ILLINOIS POWER COMPANY

December 2, 1981

Clinton Power Station Unit 1
Docket No. 50-461

"Responses to NRC Power Systems Branch Questions/Concerns"

FIGURE 1

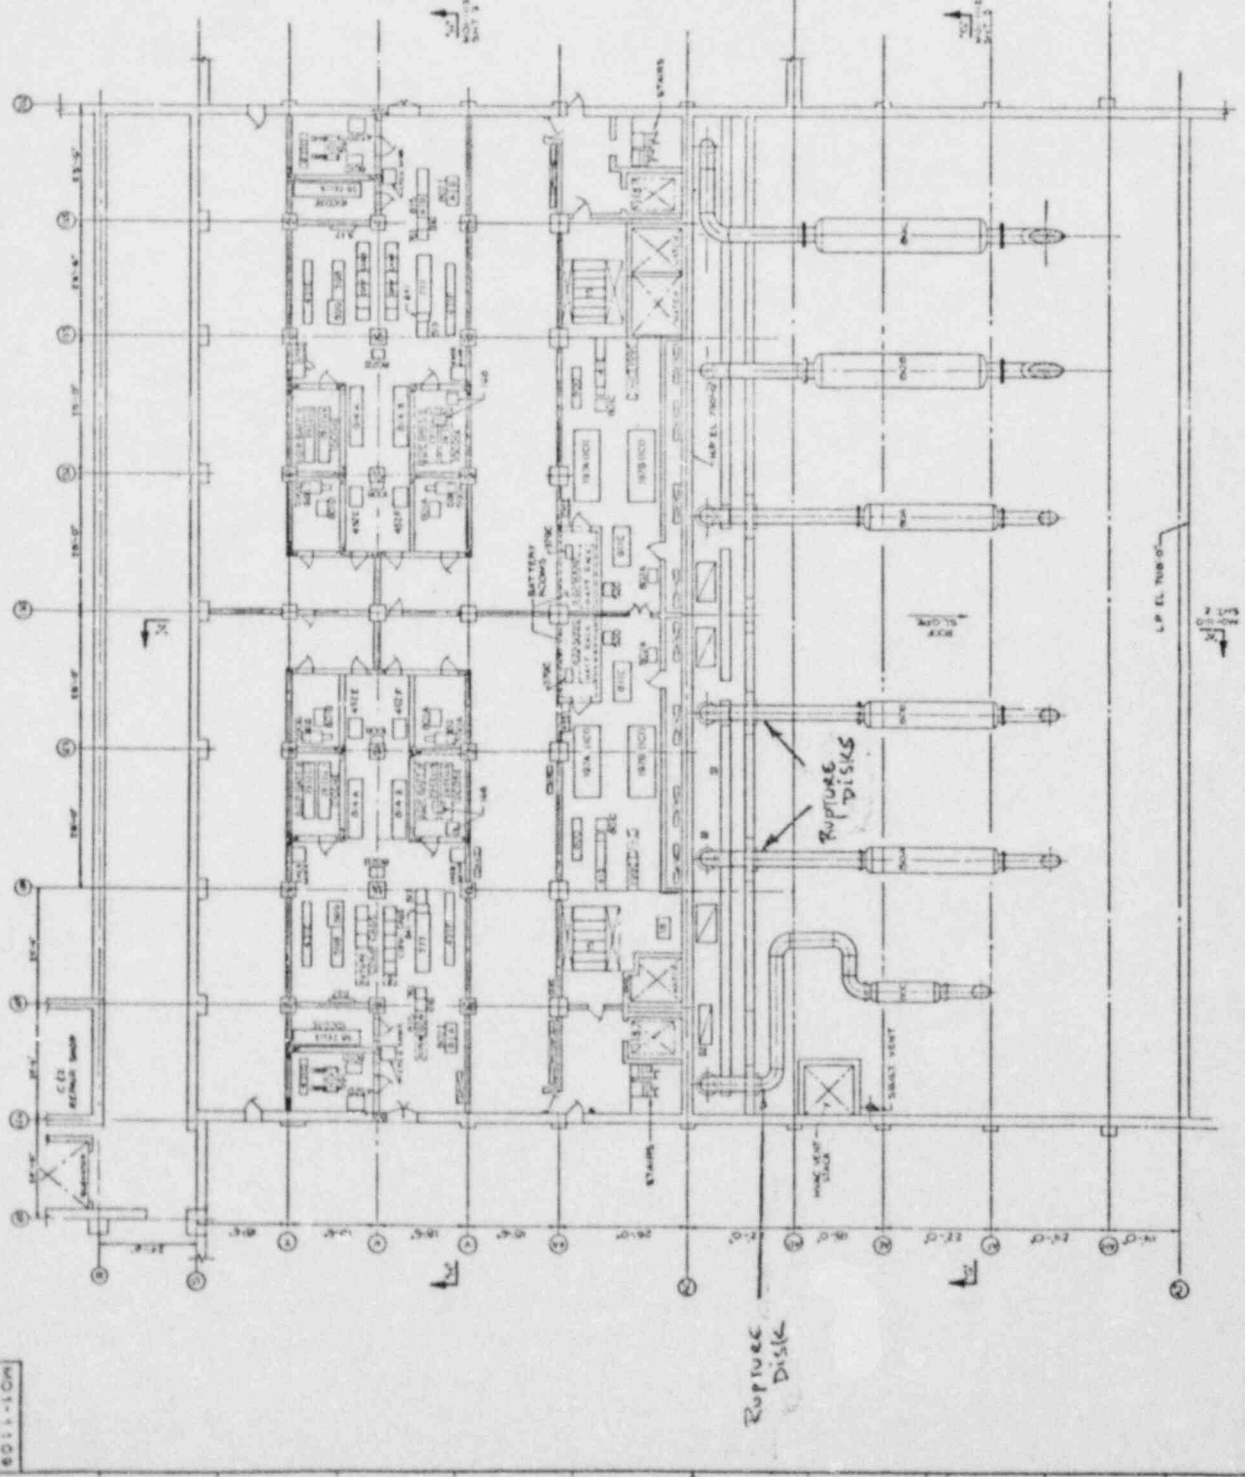
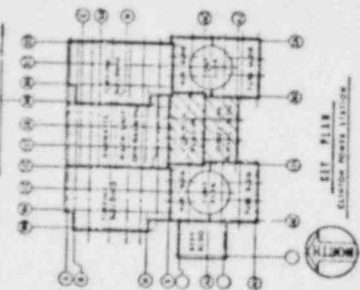
"The diesel engine exhaust silencers and associated piping are located on the roof of the diesel generator building, and are exposed to tornado missiles. A tornado missile could damage all the diesel engine exhaust piping so that the exhaust systems for all engines become restricted or blocked. This is an unacceptable situation. In addition, Table 3.2-1 shows this portion of the system as non-seismic. If such failure modes could cause a loss to diesels, a seismic Category I, tornado missile protected diesel engine exhaust system should be provided."

The horizontal portions of the diesel generator exhaust pipes located exterior to the missile wall will be exposed to horizontal tornado missiles and have not been designed to withstand these missiles. Damage to the diesel exhaust pipes from a tornado missile would result in minor deformation of or severing of the exhaust pipe. The severing of the exhaust pipe would not affect the operation of the diesel generator. Deformation of the exhaust pipe could result in a decrease in the operational performance of the corresponding diesel generator. The spacing of the diesel exhaust lines is greater than the longest credible tornado missile. A tornado missile traveling along a south - north trajectory could only damage a single exhaust line. A tornado missile traveling along an east - west trajectory would strike the first exhaust pipe and would lose energy or be deflected so that damage to the remaining pipes would not be expected.

In the unlikely event that a tornado missile crimps the diesel generator exhaust line sufficiently to exceed the diesel engine back pressure requirements, a rupture disk set at approximately 0.5 psia lower than the manufacturer's pressure limit is installed immediately next to the external head fitting on the diesel exhaust line. The location of the disk is shown on

(See revised Subsection 9.5.8.3 and figures 1 and 2).
